Rezoning Transportation Analysis

Petition Number: 2022-139

| Date | Description |
|---------|--------------------|
| 2-22-23 | Second Review (TM) |

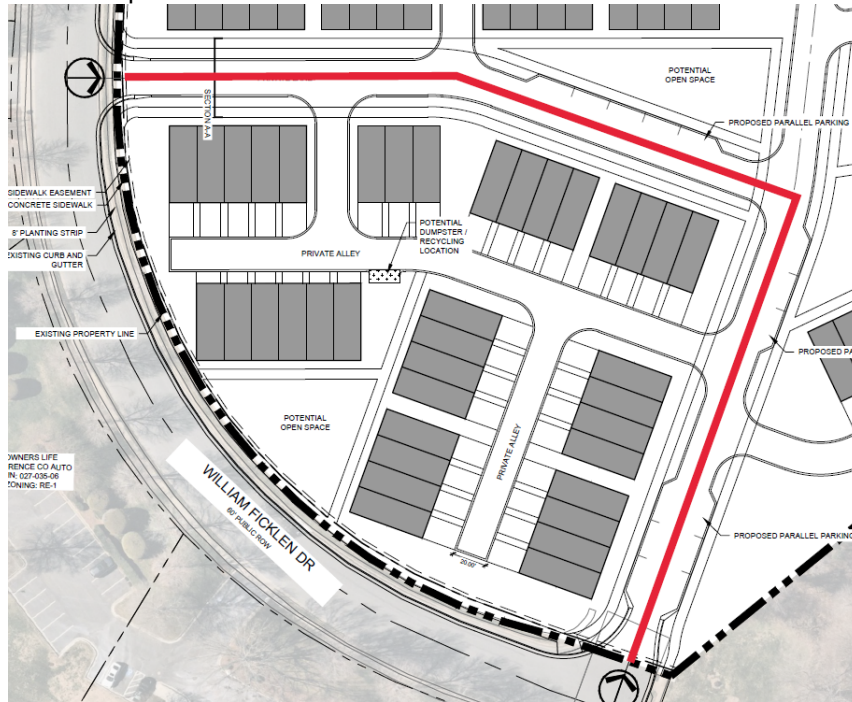
5. Revise conditional notes to commit to meeting all Intersection sight distance requirements along William Ficklen Drive frontage. If ISD cannot be met changes to site access will be required.

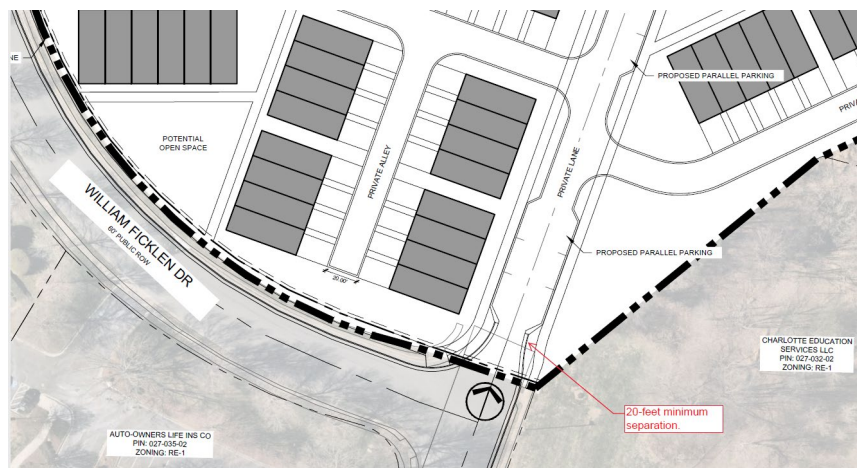
7. Revise conditional note(s) to commit to meeting intersection sight distance requirements. Site entrance locations will be required to meet all ISD requirements.
8. Revise site plan to show proper separation between the proposed on-street parking and the intersection. A minimum of 20-feet is required from the curb return to the parking stall.
